Access Compliance Report Public Rights-of-Way (Curb Ramps)

Main Street: STONYBROOK_DR Cross Street: S_GILBERT_ST Location: SE

ADA ID: RPRK210927135933 Ramp Type: Type 1 - Perpendicular Diagonal Initial Pass/Fail: Fail Overall Compliance: No Severity Score: 15

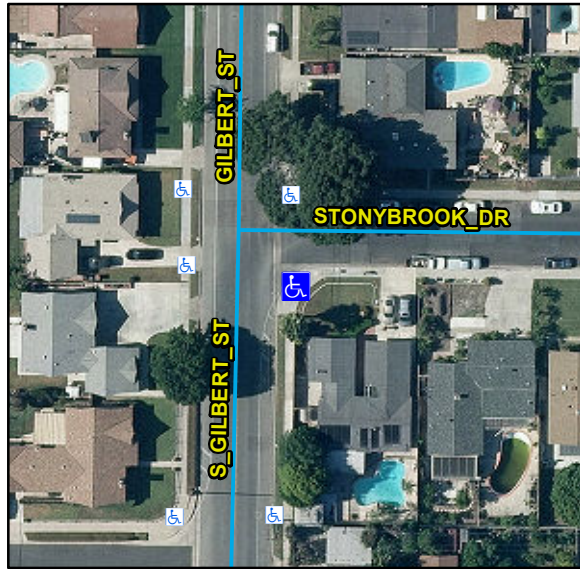
R204.3, R304.2.2, STD 1115

Remove & Replace Curb Ramp With Two New Directional Ramps or Equivalent.
